Sundry ID: 2686696

Type of Action: Plug and Abandonment

HILCORP ENERGY COMPANY
NV NAVAJO 25 #004
NOTICE OF INTENT TO PERMANENTLY ABANDON

**UNITED STATES DEPARTMENT OF THE INTERIOR
BUREAU OF LAND MANAGEMENT
FARMINGTON DISTRICT OFFICE
6251 COLLEGE BLVD.
FARMINGTON, NEW MEXICO 87402**

NV NAVAJO 25 #004 - PROPOSED P&A SCHEMATIC

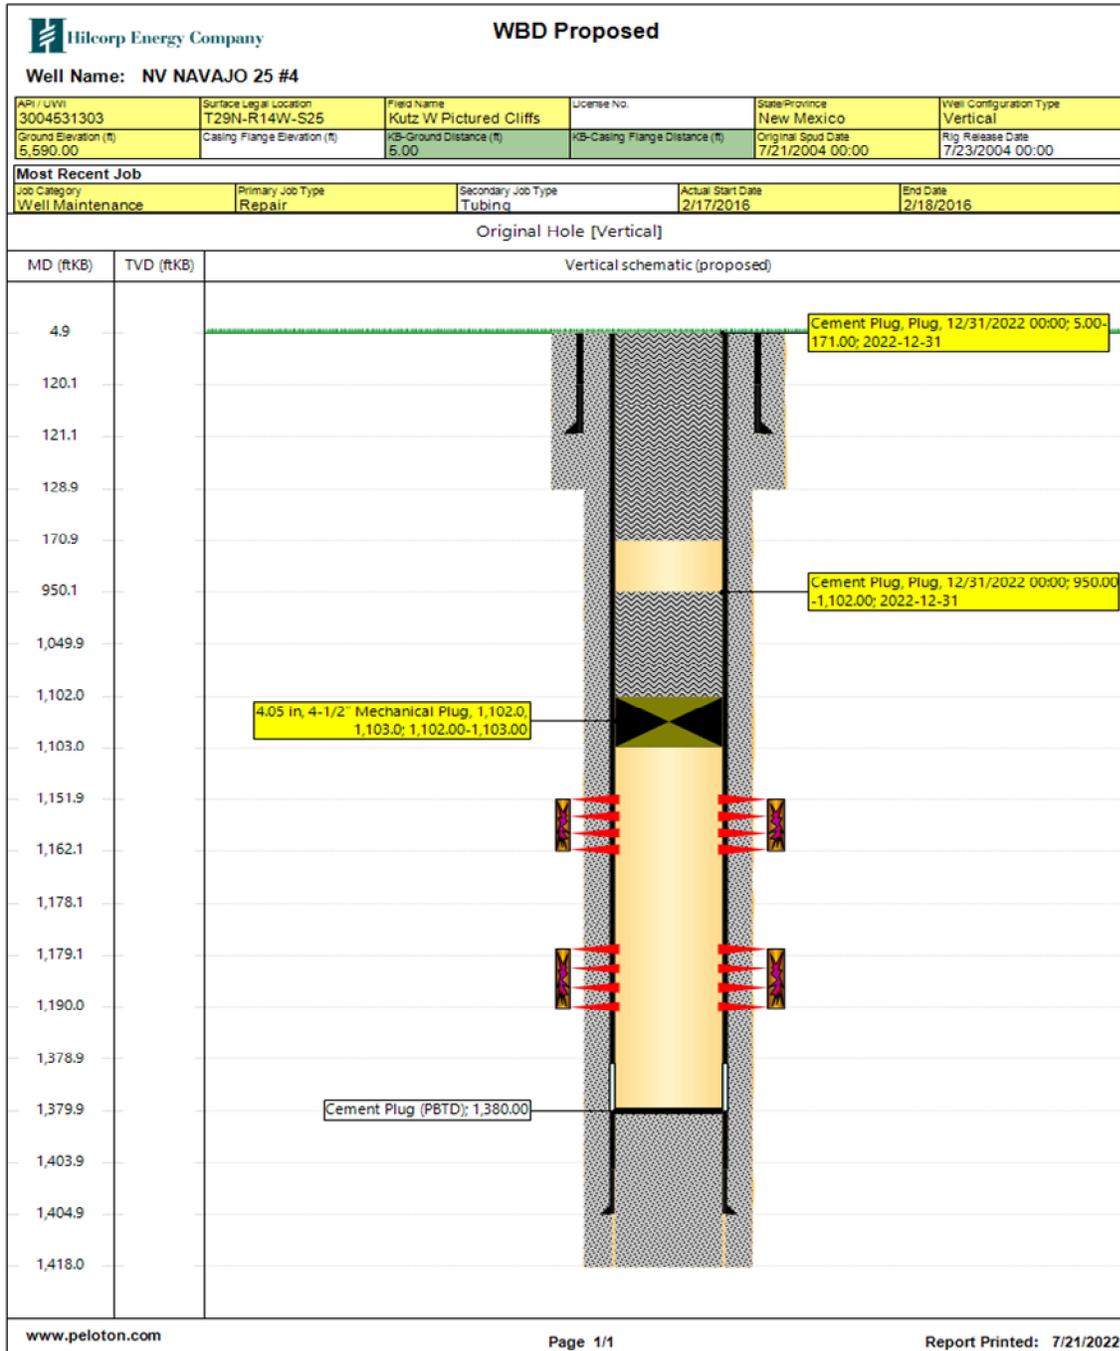
You are also required to place cement excesses per 4.2 and 4.4 of the attached General Requirements.
